URBAN DESIGN COMMITTEE

TO: **Urban Design Committee**

RE: Meeting of May 3, 2022

ITEM 2: Telegraph District Redevelopment Project

PROFESSIONAL SEAL
 SHEET NAME
 PROPOSED ARCHITECTURAL SITE
 PLAN

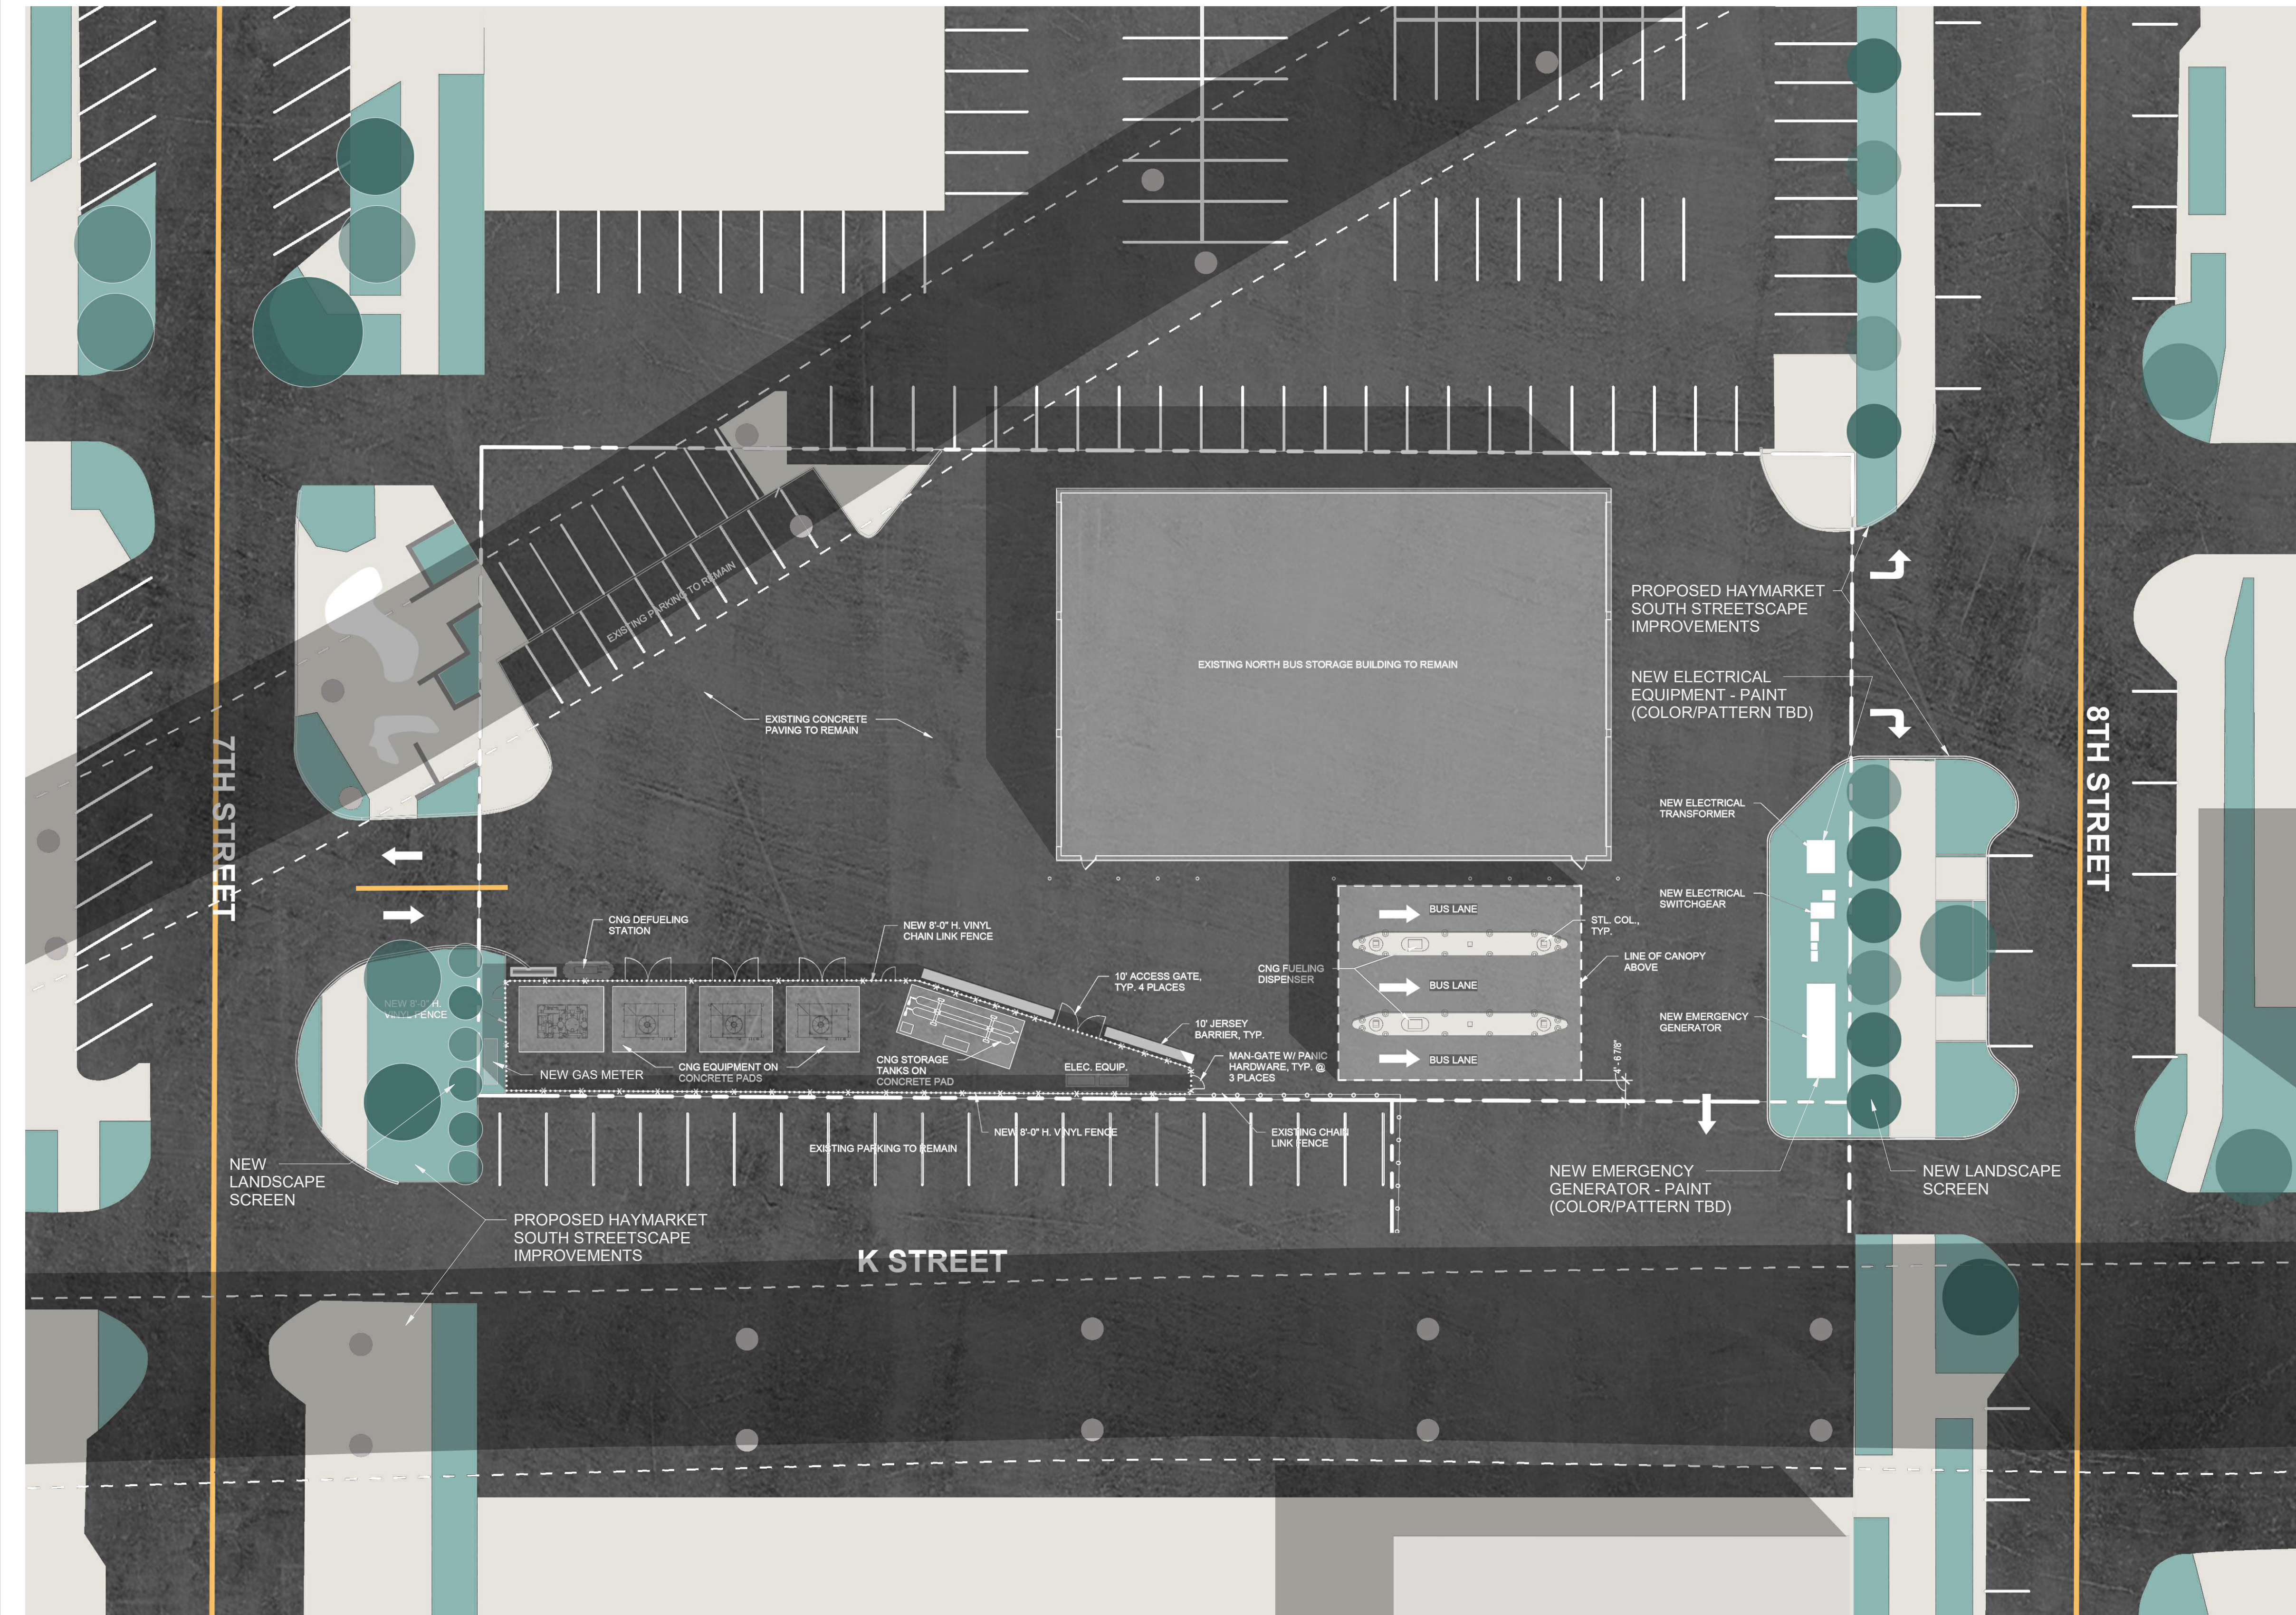
This property is within the South Haymarket area and thus the [South Haymarket Design Standards](#) govern. These design standards include standards for streetscapes which require the following: “Dumpsters, service docks, transformers, and other necessary fixtures shall be located and screened so as not to be visible from adjacent streetscapes.” The plan shows a combination of fencing and landscaping as screening materials. [Design Standards for Screening and Landscaping](#) should be considered when reviewing screening of these areas. Additional detail may be needed to sufficiently determine if these standards are met.

The plan includes the relocation and addition of Compressed Natural Gas (CNG) fueling stations to the southwest portion of the site, which will be visible not only from 7th Street but also from the

The existing view from 7th Street is shown below. The CNG fueling station, equipment, and tanks will be visible from this view. The proposed plan shows an 8' vinyl fence on the west and south sides of this equipment. An 8' vinyl chain link is shown on the other sides. Landscaping material and what appears to be two trees are shown in the greenspace adjacent to 7th Street.

Electrical equipment is proposed to be located in the current parking area on the east side of the site toward 8th Street (see view below). The proposed site plans appear to show removal of the existing street trees to allow for the sidewalk to be shifted from back of curb, the addition of a street tree, and landscape screening for the new equipment. No fence is shown on the 8th Street side. Painted artwork or vinyl wraps on the generator, switchgear, and transformer could also be considered as an appropriate treatment on the equipment.
